PROJECT: LOMBARDY PUBLIC SCHOOL PARKING, SEPTIC
AND SITE WORKS - PHASE 2 MECHANICAL AND
ELECTRICAL UPGRADES

ADDENDUM No.: 02

PROJECT No.: 209-00237-00

DATE: 2026-04-28

SITE PLAN
AR-L-100
SCALE: 1:500

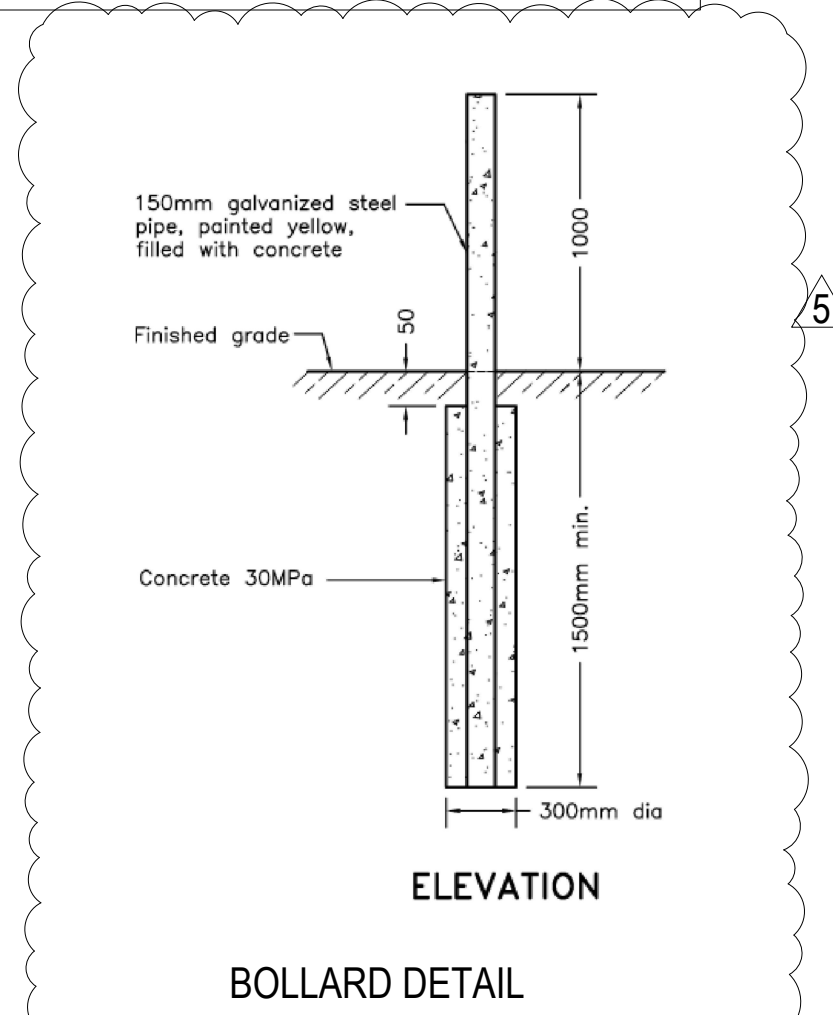
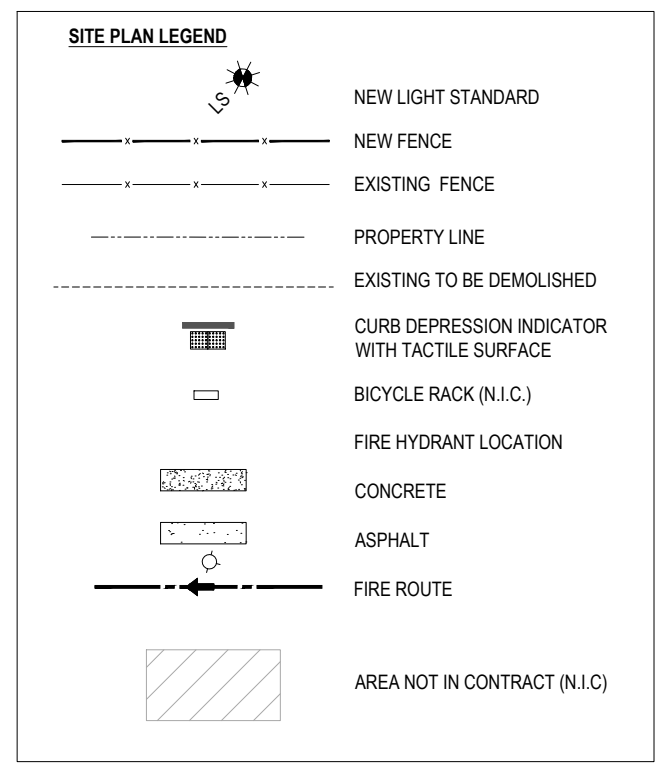
AR-L-100 SITE PLAN:

1. Addition of a bollard detail.
2. Removal of existing well-protection barriers.
3. Addition of a swing gate.
4. Correction on the extent of existing fence to remain.
5. Note for asphalt removal
6. Note for basketball post and triple shot removal and provision of new.
7. Added asphalt portion at new swinging gates.
8. Removal of redundant notes on the N.I.C. area

SHEET NUMBER: AR-L-115

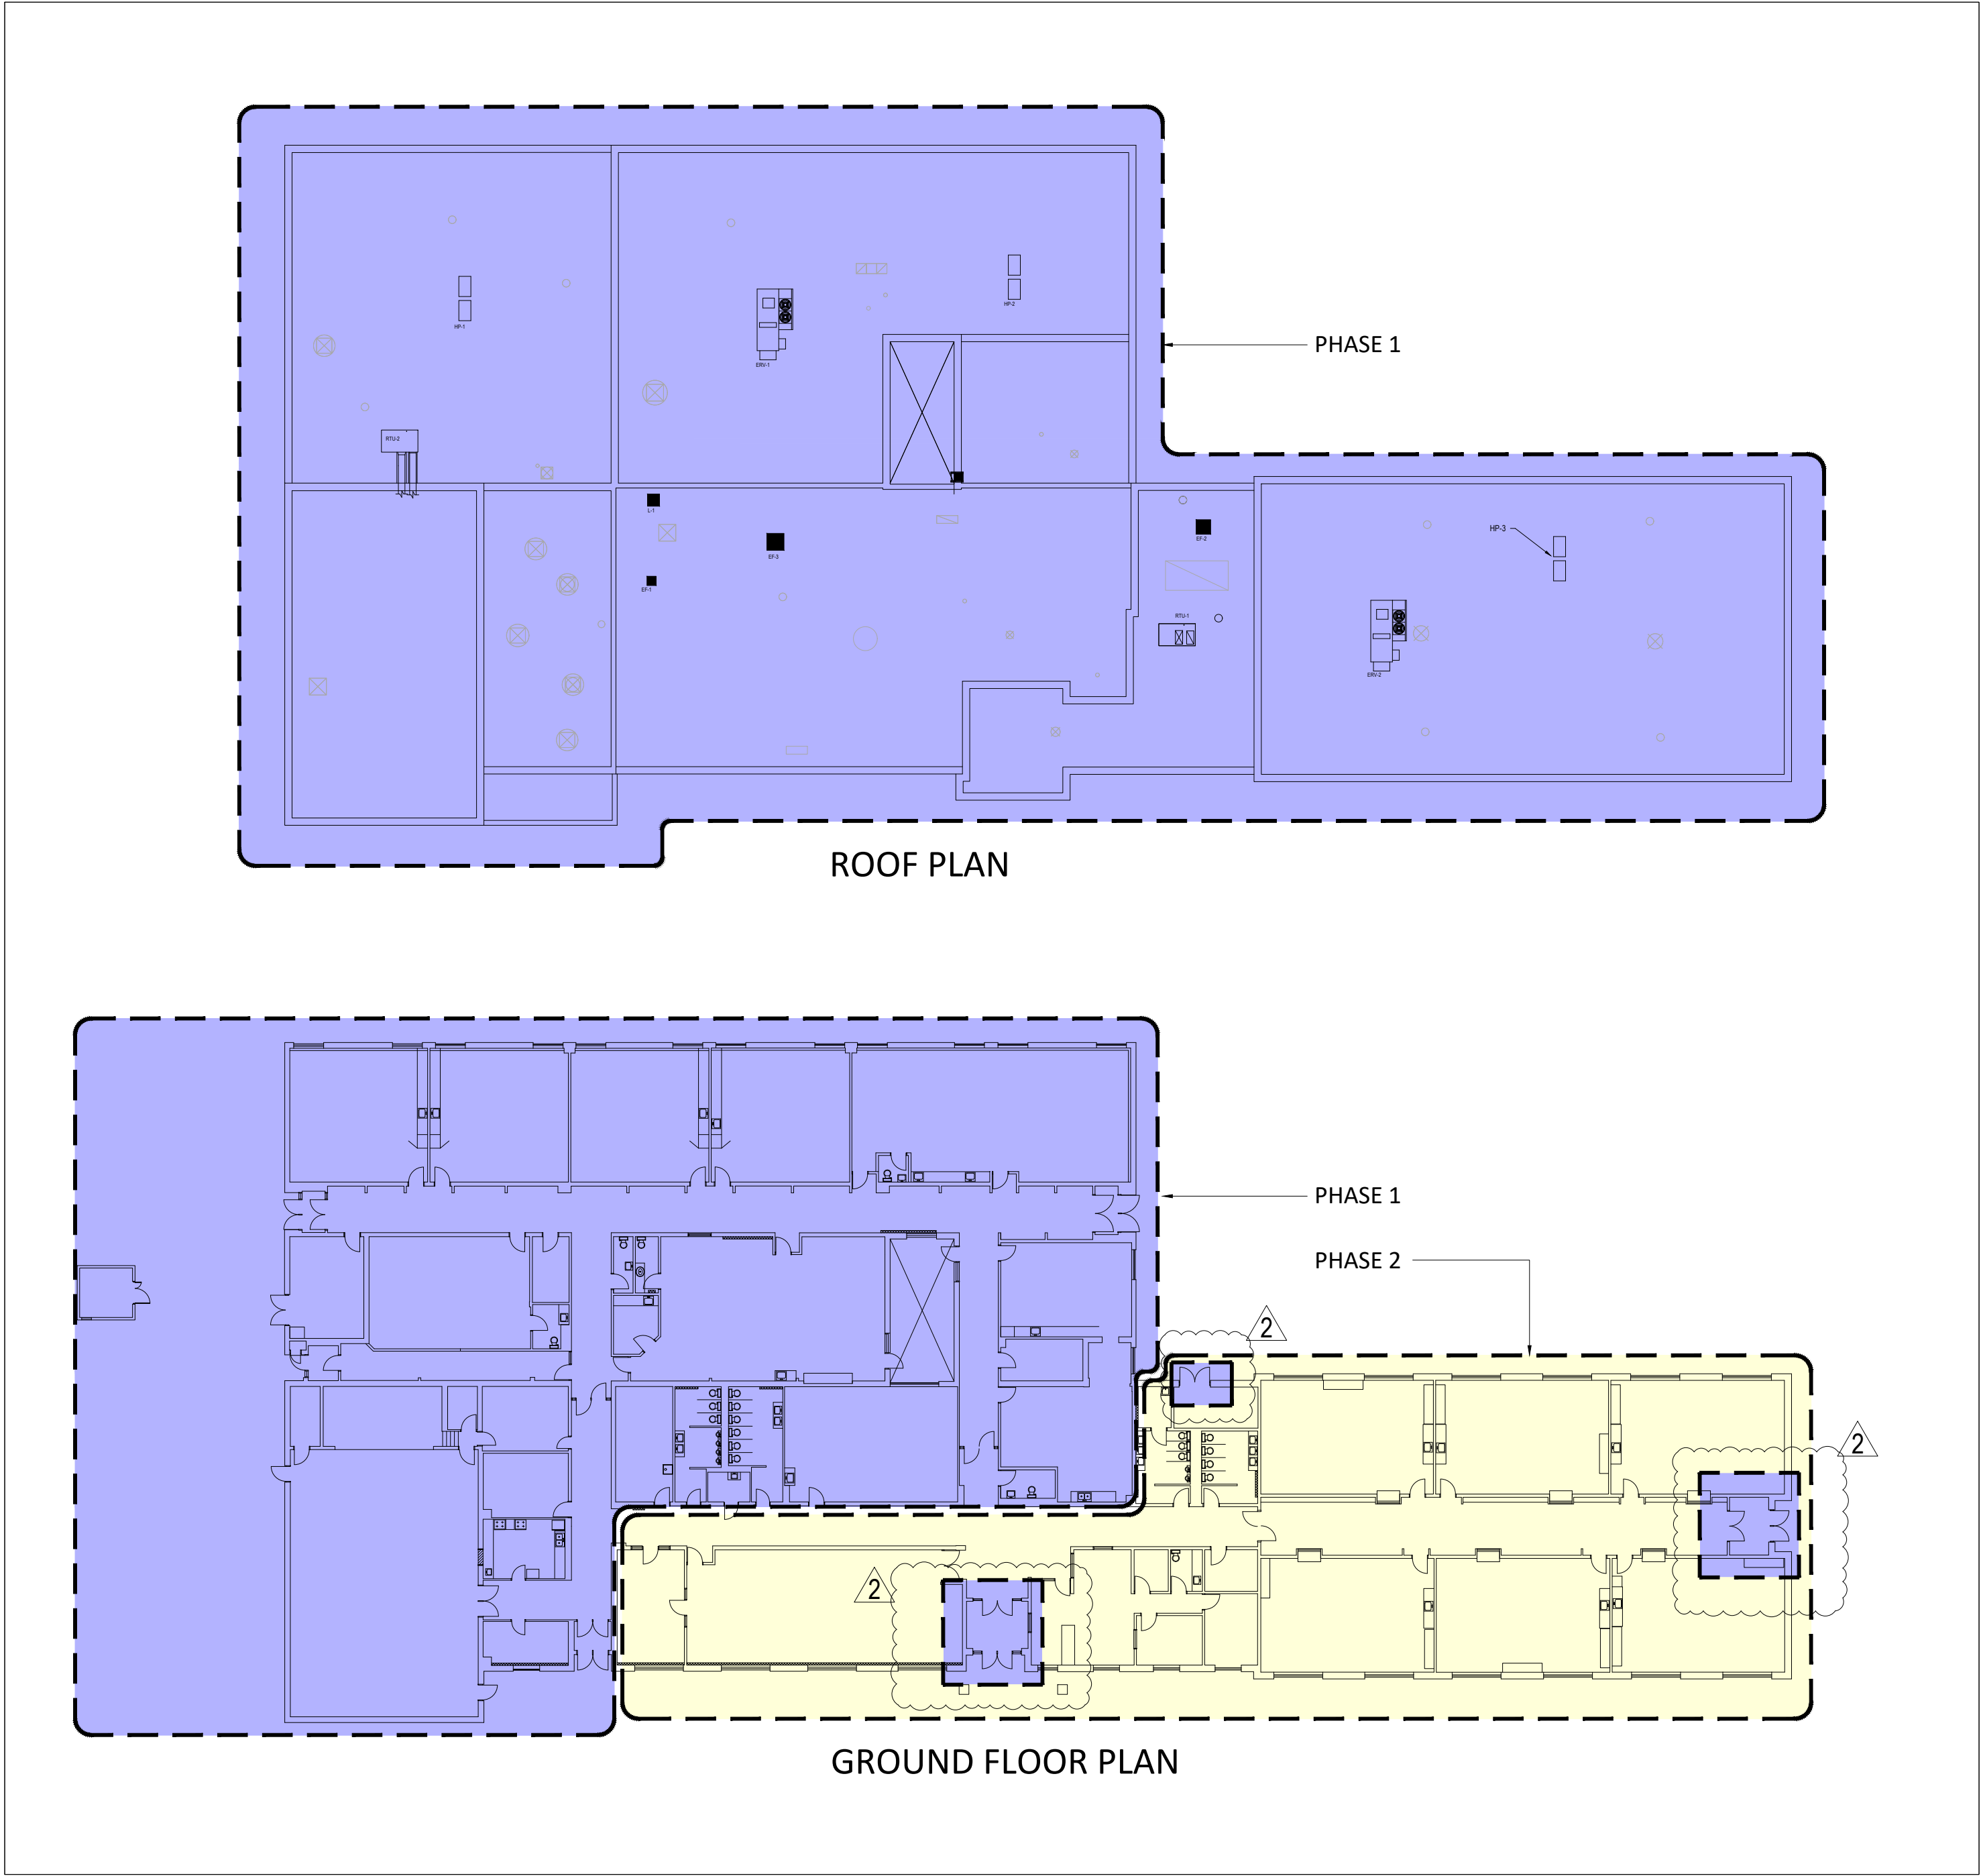
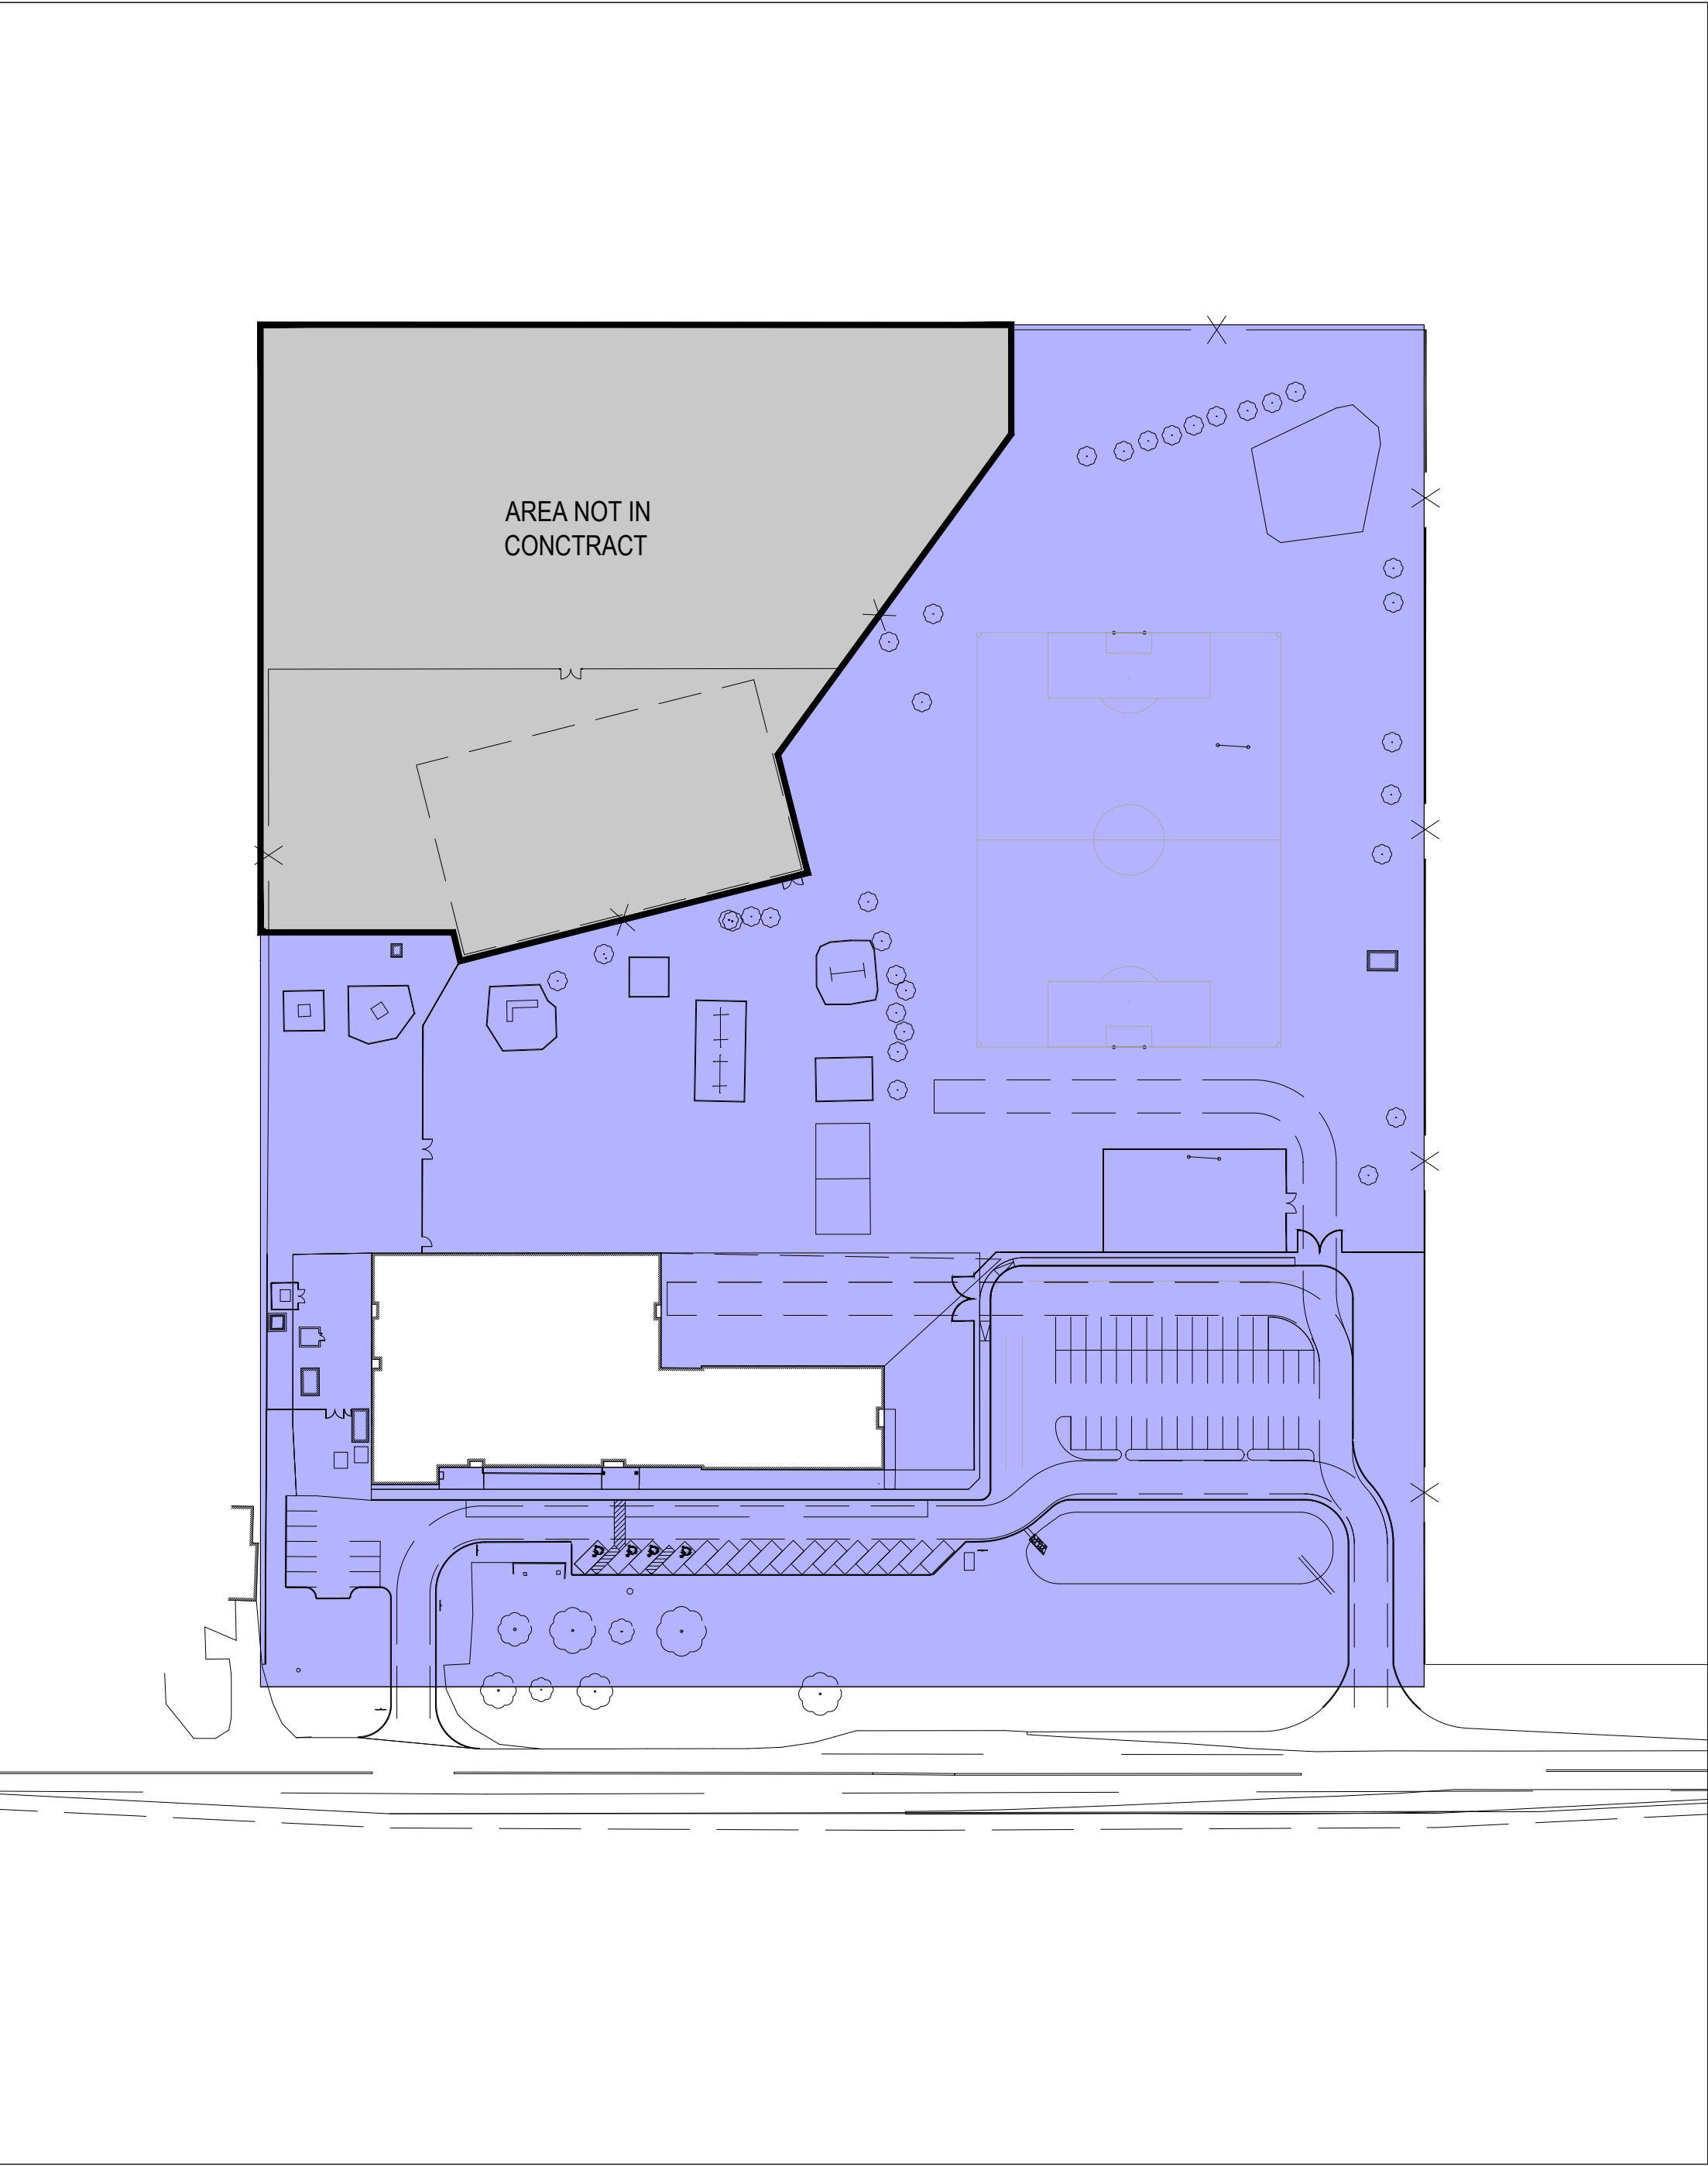
AR-L-115 PROPOSED PHASING PLAN

1. Inclusion of three exterior doors for Phase 1
2. Legend modifications.
